**Merri-bek**  
City Council

## **COUNCIL AGENDA**

### 5.1 57, 59-61 AND 59A-61 GRANTHAM STREET, BRUNSWICK WEST - PLANNING PERMIT APPLICATION MPS/2023/416

<b>Property:</b>	57, 59-61 and 59A-61A Grantham Street, Brunswick West		
<b>Proposal:</b>	Construction of buildings and works for a multi-storey, mixed-use development comprising dwellings and an office; use of the land as an office (ground floor); reduction to the standard car parking requirement.		
<b>Zoning and Overlays:</b>	<ul style="list-style-type: none"><li>Residential Growth Zone (Schedule 1)</li><li>Design and Development Overlay (Schedule 24)</li><li>Parking Overlay (PO1)</li><li>Development Contributions Plan Overlay (DCPO1)</li></ul>		
<b>Strategic setting:</b>	Minimal change	Incremental change	Increased scale of built form
<b>Objections:</b>	Four (4) objections have been received to date, which raised the following key issues. <ul style="list-style-type: none"><li>Car parking</li><li>Building scale and design</li><li>Internal and external amenity impacts</li></ul>		
<b>Objector Consultation:</b>	<ul style="list-style-type: none"><li>Council officers have spoken to objectors via phone.</li><li>An informal meeting

Figure 2 – Southern section, with the area of non-compliance in red box (TP220-C)

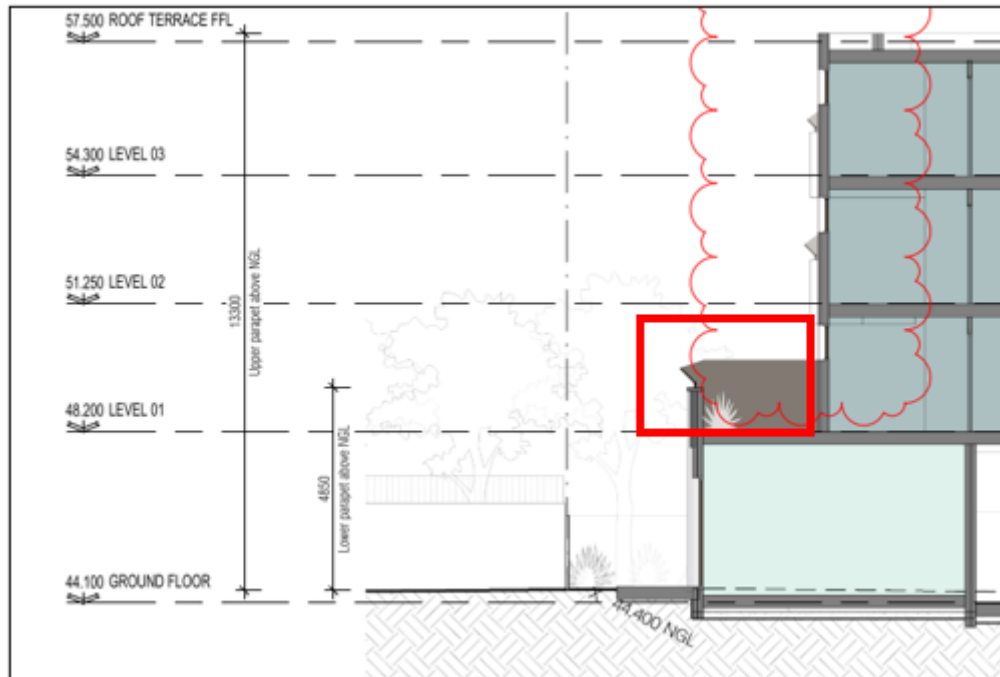
The rear elevation is generally compliant with DDO24 requirements from and above Level 1, save for the first-floor balconies of Apartments 104 and 105 within the preferred 6 metre setback requirement by between 1.5 and 3 metres. As shown in the image below, the balustrades essentially form a modest extension to the ground-floor wall.

This variation is considered acceptable, given:
